DRAFT RESPONSE TO TASK INTERFACE AGREEMENT
2014-05 RELATED TO DESIGN BASES AND LICENSING
BASIS FOR UNDERGROUND CABLE
CONFIGURATIONS AT OCONEE
NUCLEAR POWER STATION, UNITS 1, 2, AND 3

Cable Shield and Armor in Power Cables

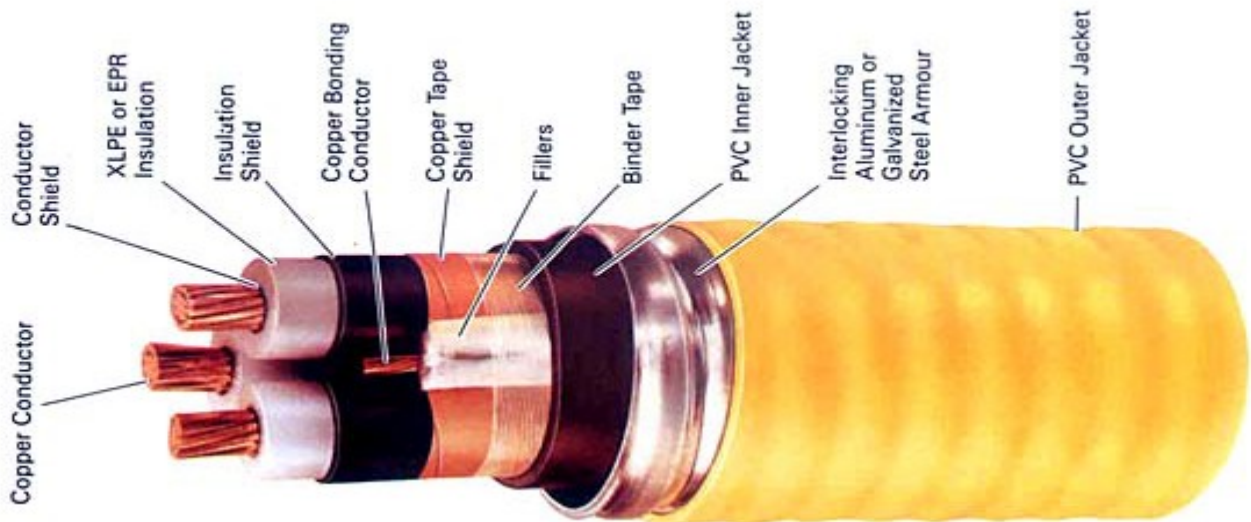
Question 2J: Can cable shielding or armor prevent short circuits or limit faulted currents and voltages?

- Can the two wraps of bronze shielding tape in the licensee's current power cable configuration be considered equivalent to the steel interlocked armored cable as described in the test report MCM-1354.00-0029.001?
- Are the results of test report MCM-1354.00-0029.001 sufficient to demonstrate that electrical faults cannot propagate from one cable to another as described in the single failure DBD, Section 3.3.6.1?

Response 2J: No. Both Cable shielding and Armor cannot be credited for preventing short circuits or limiting fault currents and voltages. Cable shielding and cable armor serve different functions. A shield is employed in the subject cable design to preclude excessive voltage stress on voids between the conductor and insulation, and to confine the electric field of the cable to the insulation of the conductor or conductors.
